# Policy Newsletter

# January 2026

# Policy updates – major policy updates

9.5.1. Drawing No HQ.4.52.30-33

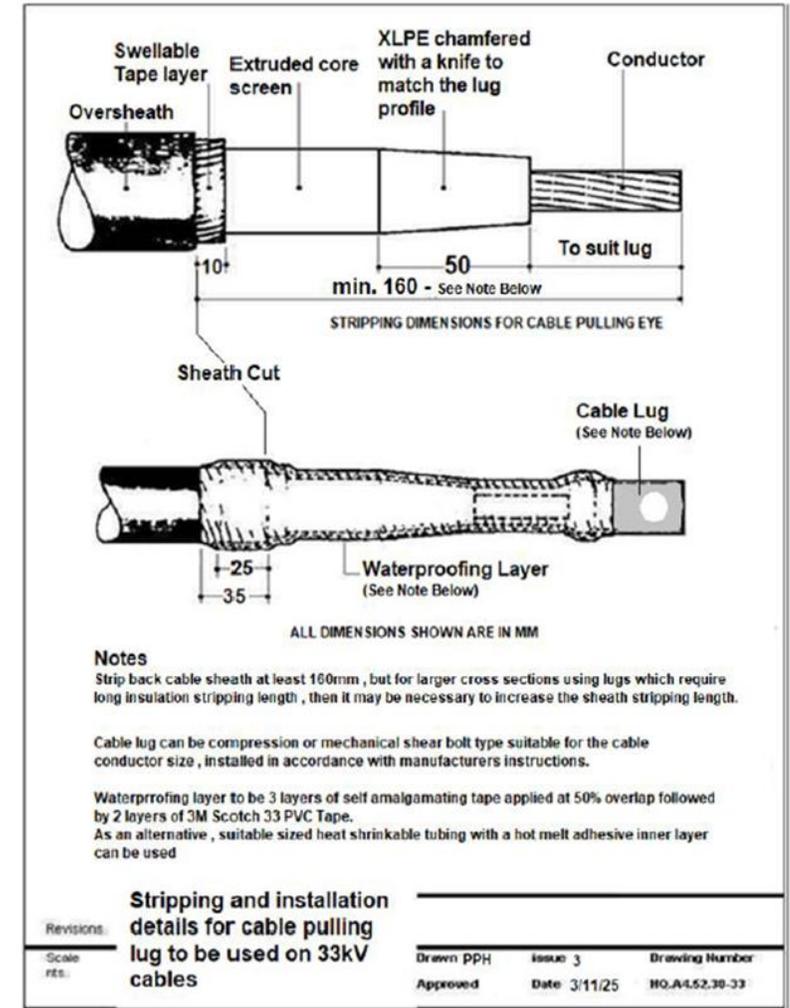
Update to Drwg HQ.4.52.30-33 and minor formatting changes.

- Updated Drwg HQ.4.52.30-33 on pulling lug for 33kV cables to allow use of mechanical shear bolt type lug.
- Minor formatting updates.
